Section 00 9113 Addendum No. 2

SECONDARY WATER SUPPLY CITY OF FLINT, MICHIGAN

CITY OF FLINT
1101 S. SAGINAW STREET
FLINT, MI 48502
36" SECONDARY WATER SUPPLY
PLAN AND PROFILE SHEET 4

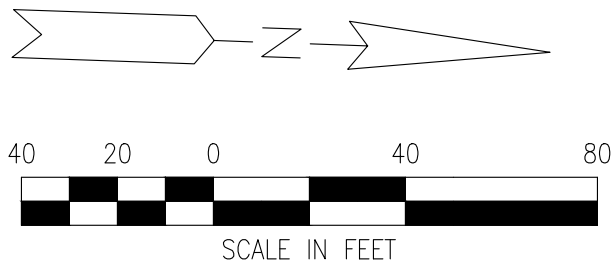
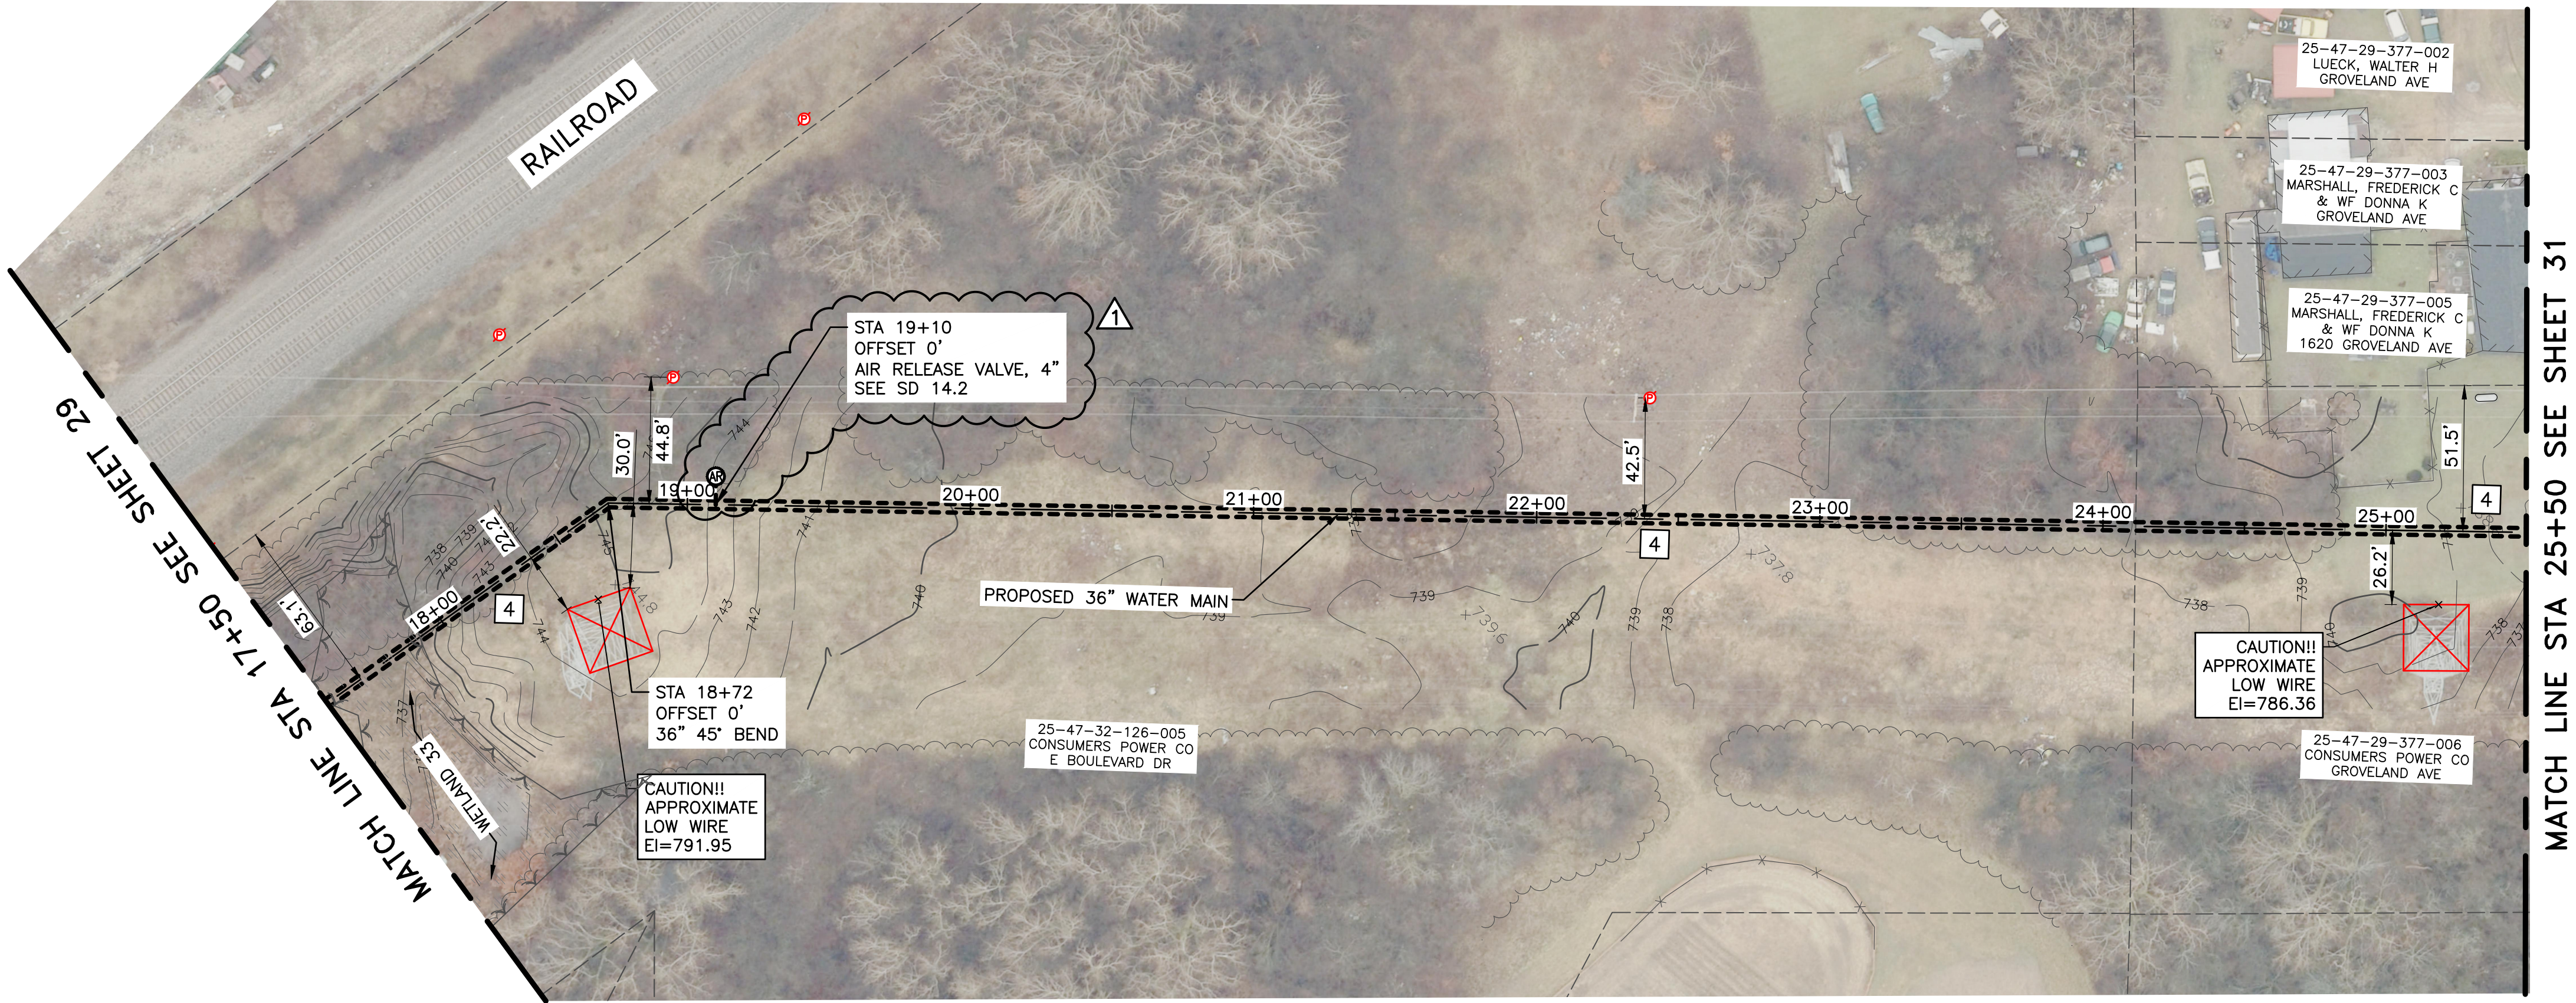
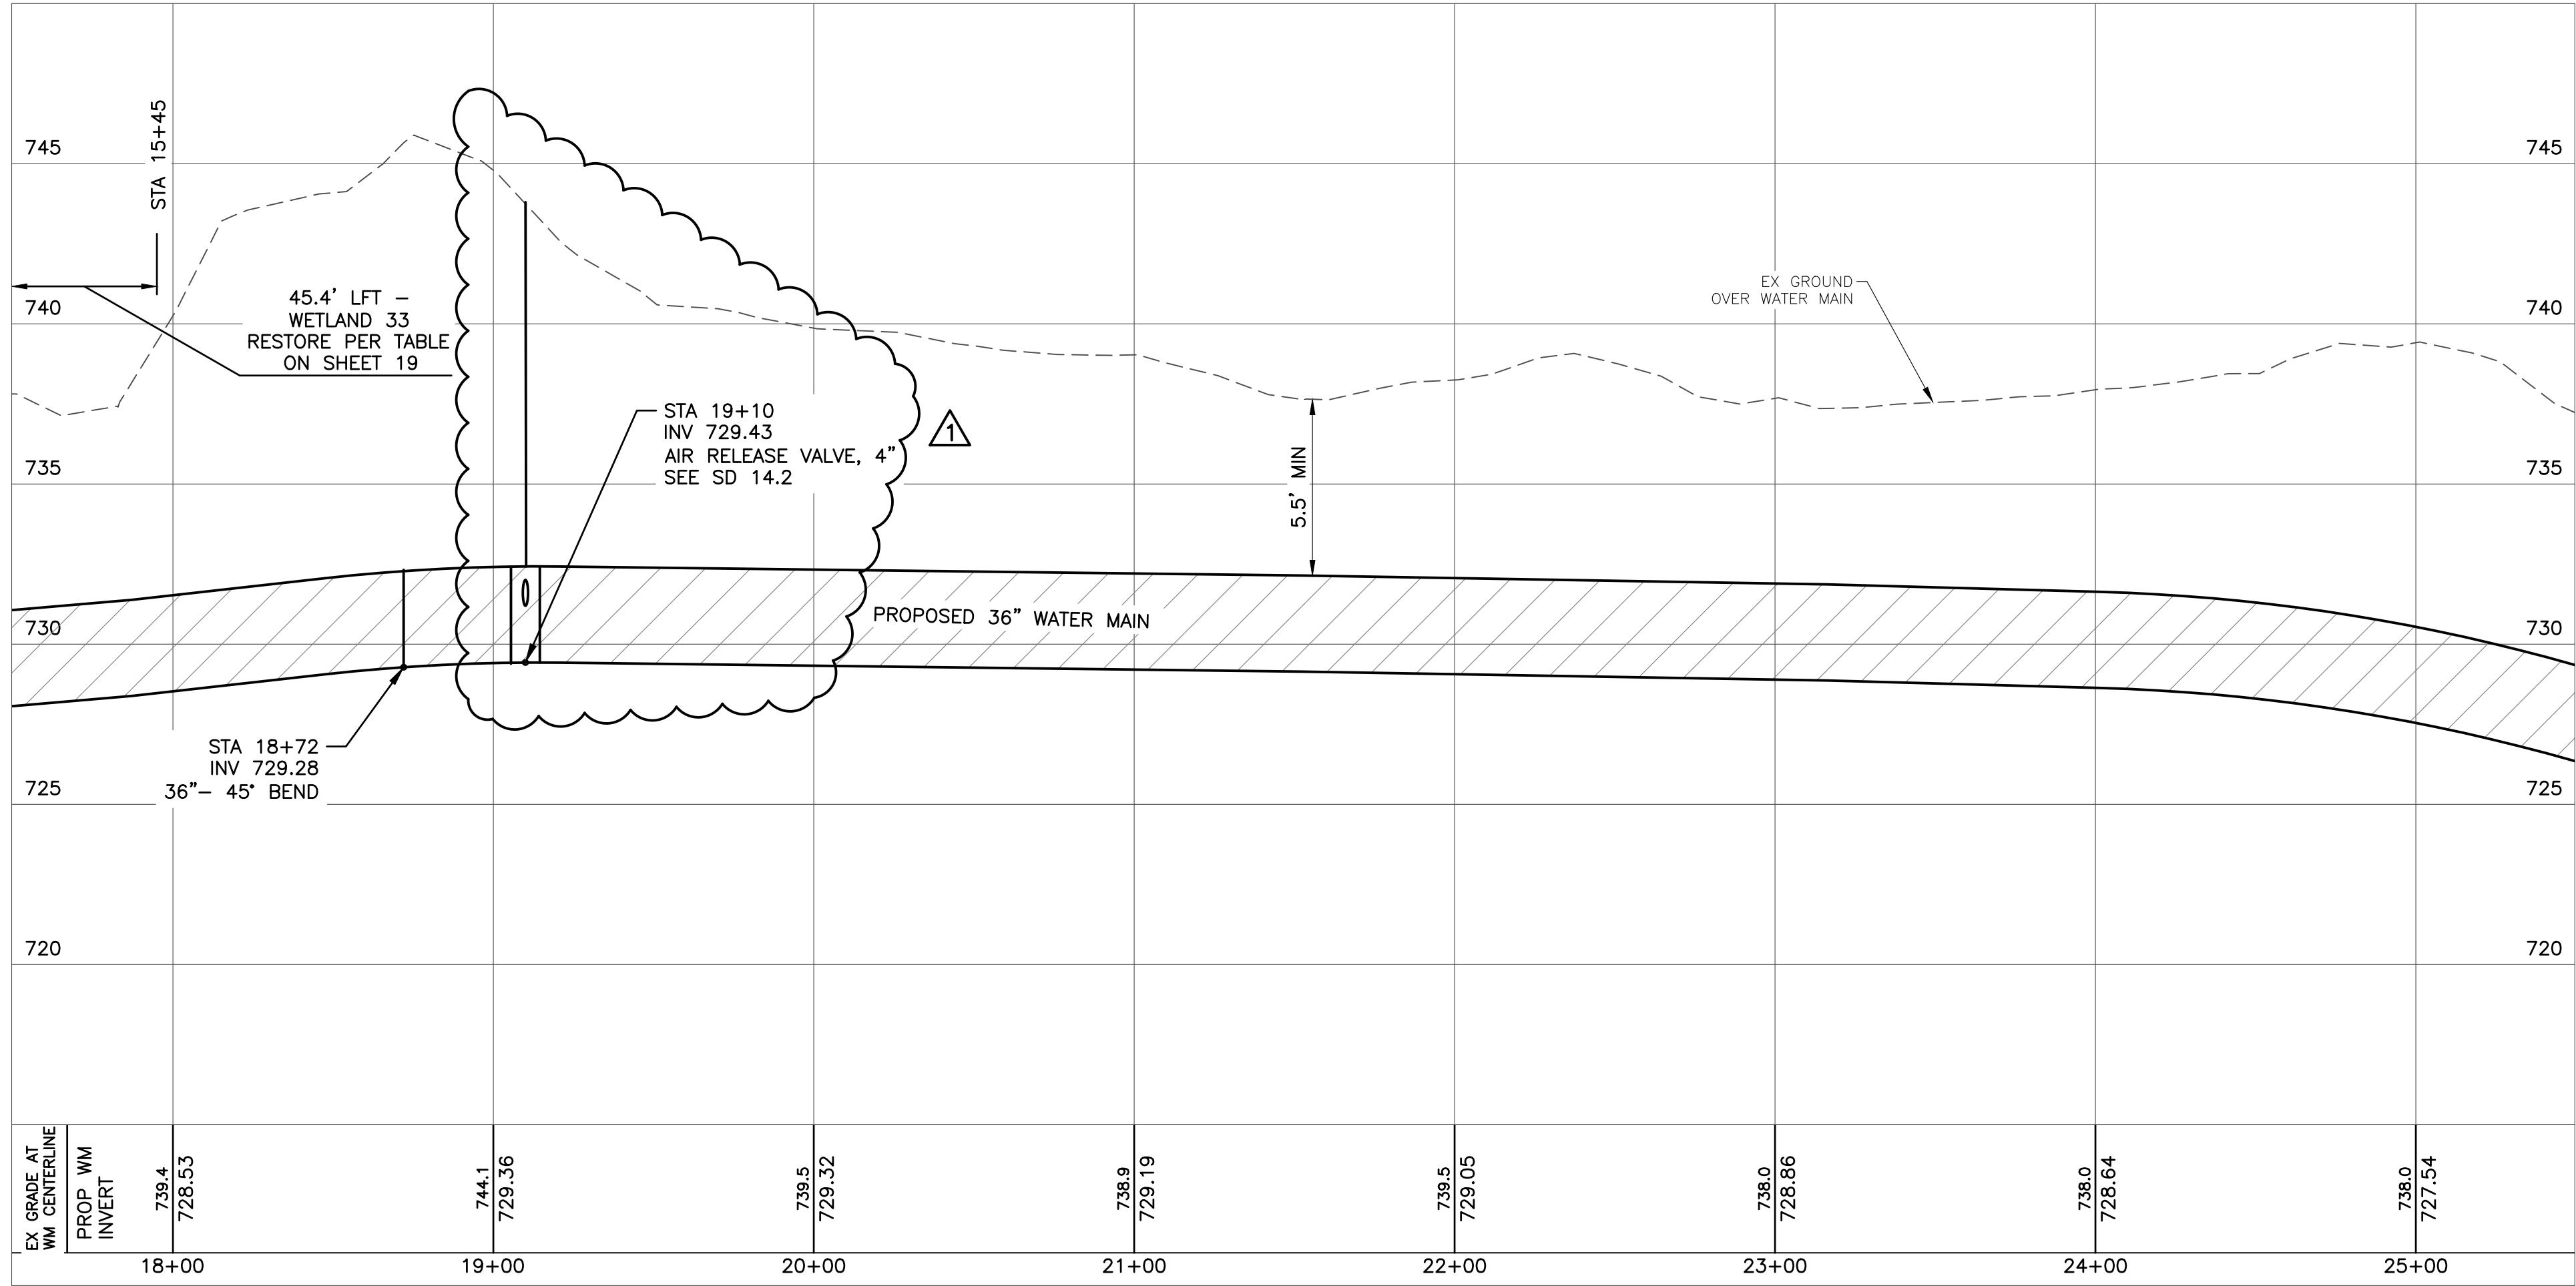
<u>Sheet</u>	<u>Description of Change</u>
54	The following note shall be added to Sheet 54: 8. CONTRACTOR TO PROVIDE TEMPORARY CULVERT (AND AGGREGATE MATERIAL AROUND CULVERT) AT DRAIN CROSSING TO ALLOW FOR ACCESS DURING CONSTRUCTION ACTIVITIES. CONTRACTOR TO REMOVE CULVERT AND AGGREGATE MATERIAL AT COMPLETION OF PROJECT. COST FOR THIS CULVERT IS INCIDENTAL TO THE PROJECT.
61	Sheet 61 is to be replaced in its entirety with Sheet 61 that accompanies this Addendum.
63	The following note shall be added to Sheet 63: 8. CONTRACTOR TO PROVIDE TEMPORARY CULVERT (AND AGGREGATE MATERIAL AROUND CULVERT) AT DRAIN CROSSING TO ALLOW FOR ACCESS DURING CONSTRUCTION ACTIVITIES. CONTRACTOR TO REMOVE CULVERT AND AGGREGATE MATERIAL AT COMPLETION OF PROJECT. COST FOR THIS CULVERT IS INCIDENTAL TO THE PROJECT.
65	Sheet 65 is to be replaced in its entirety with Sheet 65 that accompanies this Addendum.
P-1	Sheet P-1 is to be replaced in its entirety with Sheet P-1 that accompanies this Addendum.
